*SUPPLEMENTAL  
ENVIRONMENTAL  
IMPACT REPORT  
FOR  
HIGH SCHOOL NO. 5*

*SCH NO. 2002101020*

**Section 2, Response to Comments.** This section provides a list of agencies and interested persons commenting on the DSEIR; copies of comment letters received during the public review period, and individual responses to written comments. To facilitate review of the responses, each comment letter has been reproduced and assigned a number (A01 through A09 for letters received from agencies and organizations, and R01 for the letter received from interested individuals). Individual comments have been numbered for each letter and the letter is followed by responses with references to the corresponding comment number.

Figure 1a      Underground Tank Locations

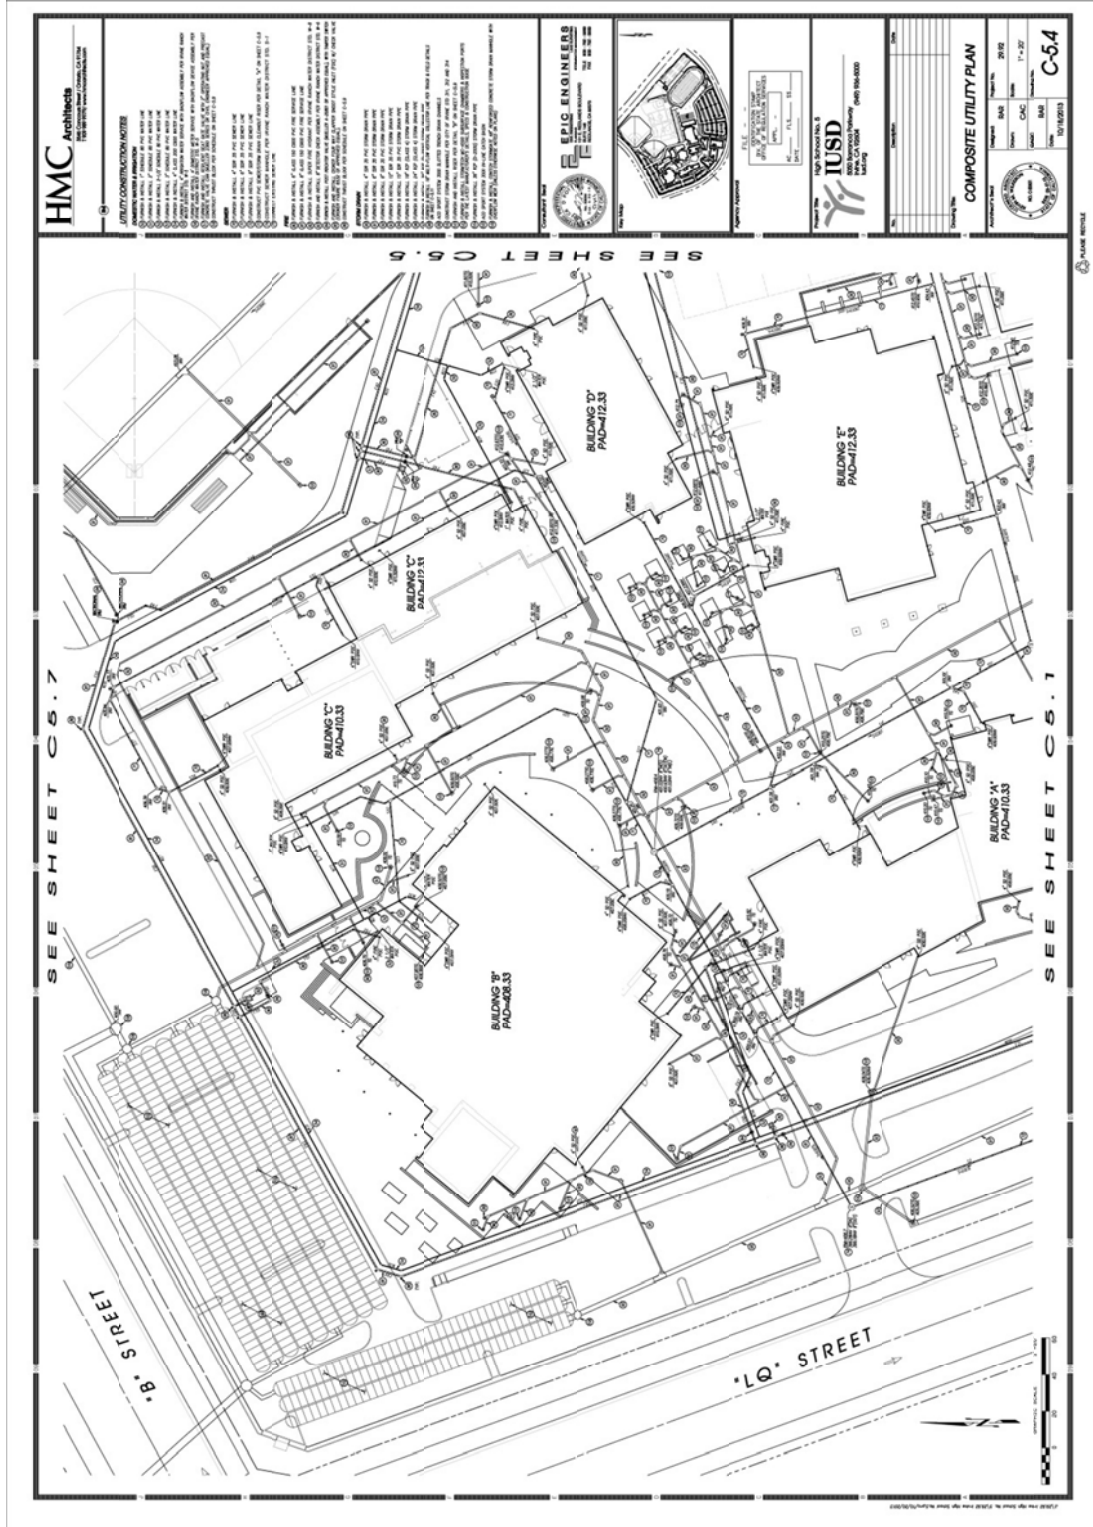
Regional Board staff also requests that appropriate site plans in the final SEIR show the approximate location(s) of the underground tanks and any other structural treatment controls that have the potential to create conflicts. Regional Board staff requests that the structural treatment controls be shown in the final SEIR whether they are developed through the WQMP process or through compliance with the Construction General Permit's post-construction requirements.

- A01-2 The District is currently preparing a WQMP per the City of Irvine's template. However, based on the conversation with Michael Yang, PE., City of Irvine Senior Water Quality Engineer, because no permit is requested from the City by the District, the City is not required to review or approve the WQMP for the Proposed Project. Although it will not be reviewed by the City, the WQMP will include other structural treatment controls per the City of Irvine's standards as necessary to ensure that no potential water quality conflicts occur. Please see Appendix A, *Rough Grading Plans*, for the underground tank locations.

- A01-3 See A01-2. Refer to Figures 1a and 1b, following this page.
- A01-4 The construction of public rights-of-way around the perimeter of the high school referenced in this comment will be completed by the developer prior to the District's acquisition of the site. The developer will be responsible for related structural treatment controls for runoff from the public rights of way.
